**NEI 99-02 FAQ 19-02 - Final Response
Brunswick RCS Leakage**

Plant: Brunswick Nuclear Power Plant Unit 1

Performance Indicator: BI02 - Reactor Coolant System Leakage

Figure 1, RCS Leak location

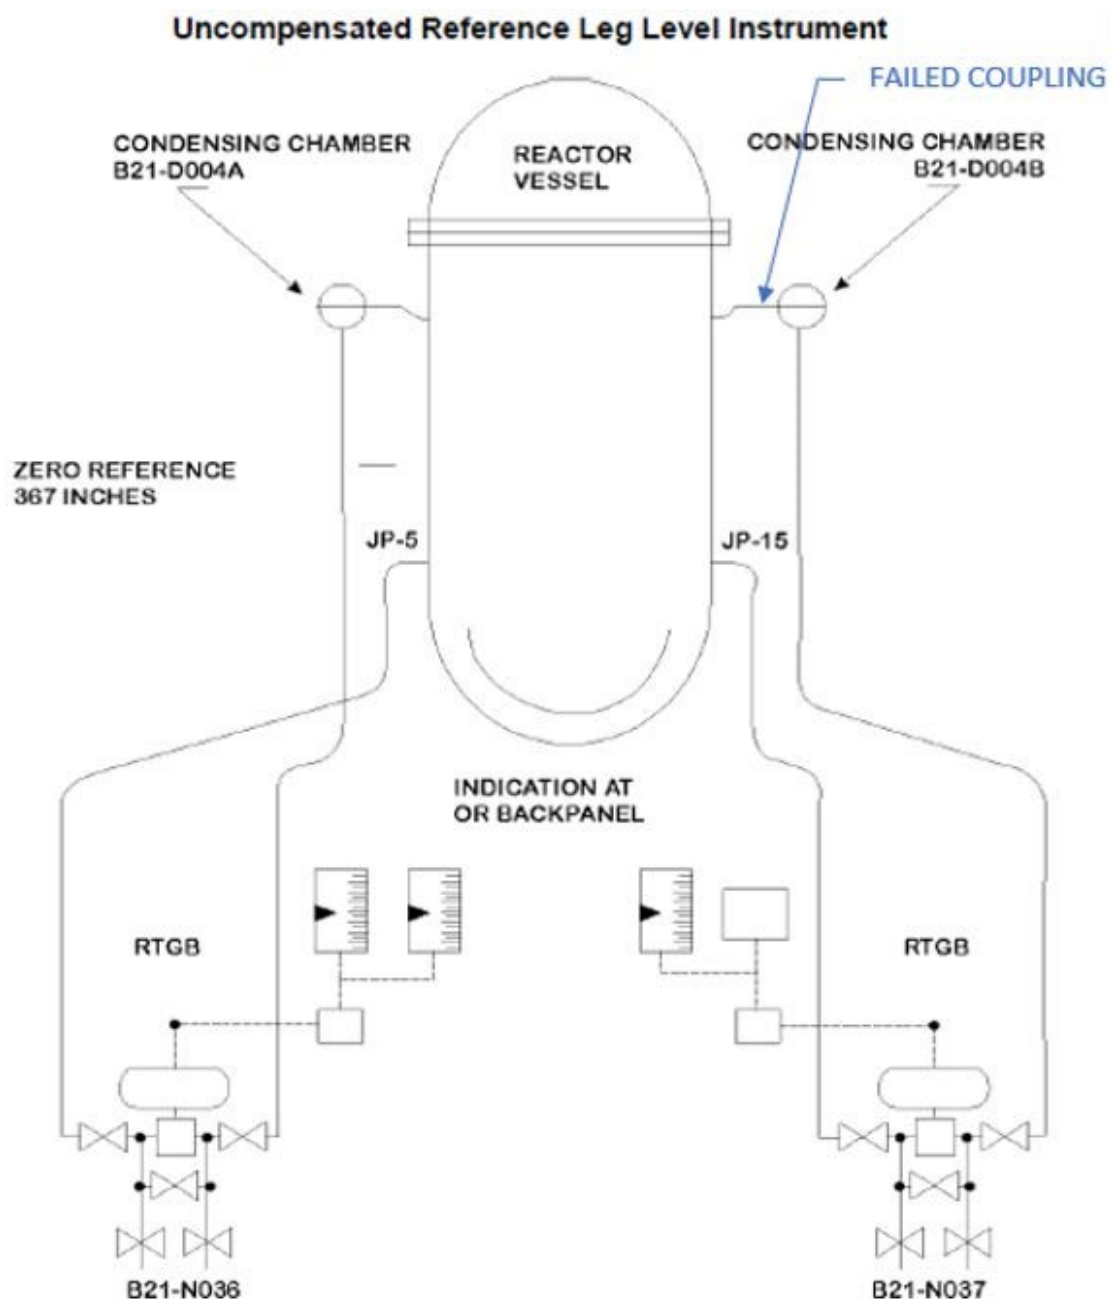
Investigation inside containment determined that a 1-inch coupling on line 1-B21-774 located on the steam side of a reactor level condensing chamber experienced a 360° circumferential separation at the approximate center of the coupling as shown in Figures 1 and 2 below. This opened a path for steam from the reactor to leak into the drywell. Reactor water level was maintained in the established level band, below the level of the sensing line nozzle, throughout the event. The impact from the coupling failure has been analyzed by the Duke Probabilistic Risk Assessment staff and determined to be very low safety significance.

Figure 3, March 2019 Reported RCS Leakage (4-hour periodicity)

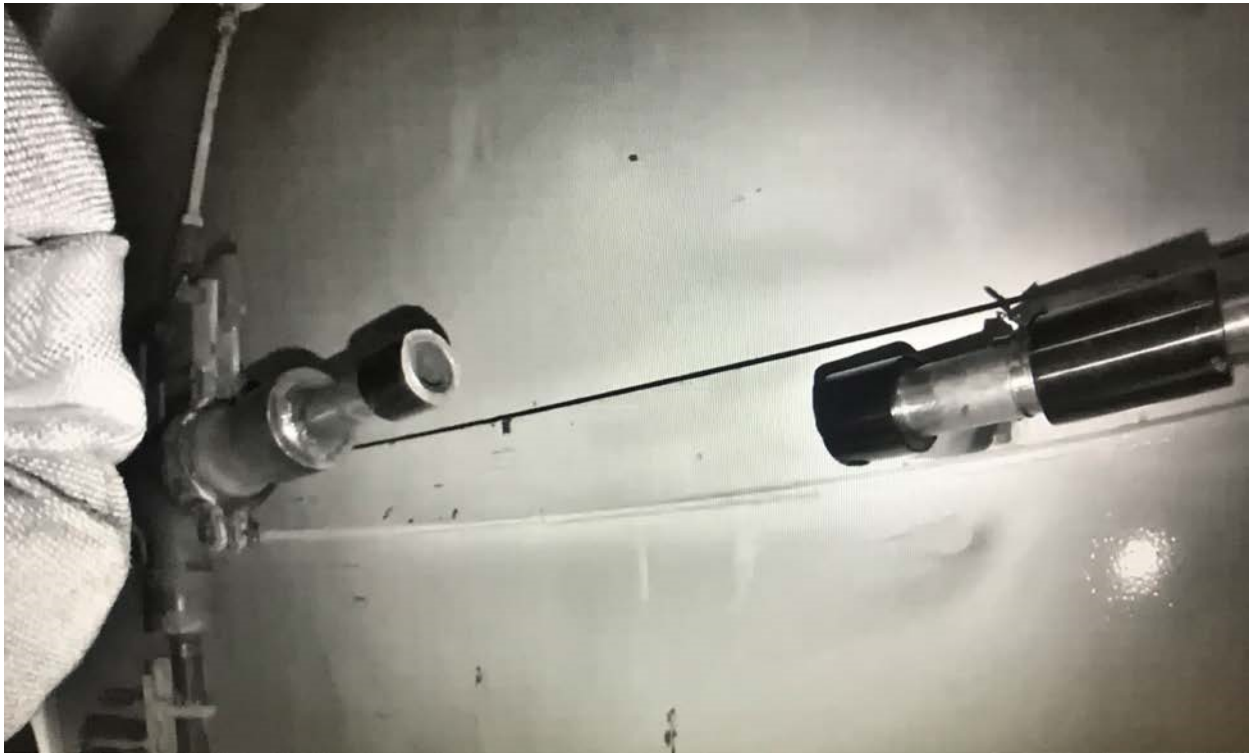
The PI is intended to monitor leak-before-break situations that are viewed as precursors of a more catastrophic failure. In the Brunswick event, RCS Total leakage had been steady for the month of March as shown below in Figure 3. There was no advanced indications of degradation or leakage from the coupling and no trend that worsened over time due to operator inaction.

As shown in Figure 3, RCS Leakage trends were stable and low in the Green performance band for the month leading up to the coupling failure. The coupling failure occurred without warning. Drywell leakage and temperature in the vicinity of the coupling did not increase prior to the failure. There was no opportunity for Operations staff to identify this condition in advance of failure. As no precursors were present, no mitigating actions could have been taken in advance of the leak and the actions taken following the leak indicate prompt and conservative response on the part of the licensee. In addition, the location of the leak prevented it from being isolated until the plant was depressurized, which added to the volume of the leakage calculated in the PI. Despite timely operator actions to accomplish this, the volume of leakage calculated in the PI resulted in one calculation data point exceeding the threshold for White. The degradation mechanism of the coupling will be evaluated under other NRC processes.

The staff does not dispute research showing a high probability of leak before break of RCS pressure boundary passive components, even though that did not occur in this case. The staff also acknowledges that the RCS leakage PI can provide RCS leakage insights such that it can be identified prior to a break. Nevertheless, the PI is defined in IMC 0608 with supporting guidance in NEI 99-02 and the objective of the PI is discussed in IMC 0308, Attachment 1. The objective of the PI is to monitor the integrity of the RCS pressure boundary. Also, the referenced SECY 99-07 above states that “*An actual RCS leak is, by definition, a breach of RCS integrity and a direct indicator of the performance of the RCS pressure boundary*” which is consistent with the PI objective. In conclusion, to discount an actual RCS leak or break because it was sudden rather than gradual, or because corrective actions were timely and effective, is wholly inconsistent with the stated objective of the PI.
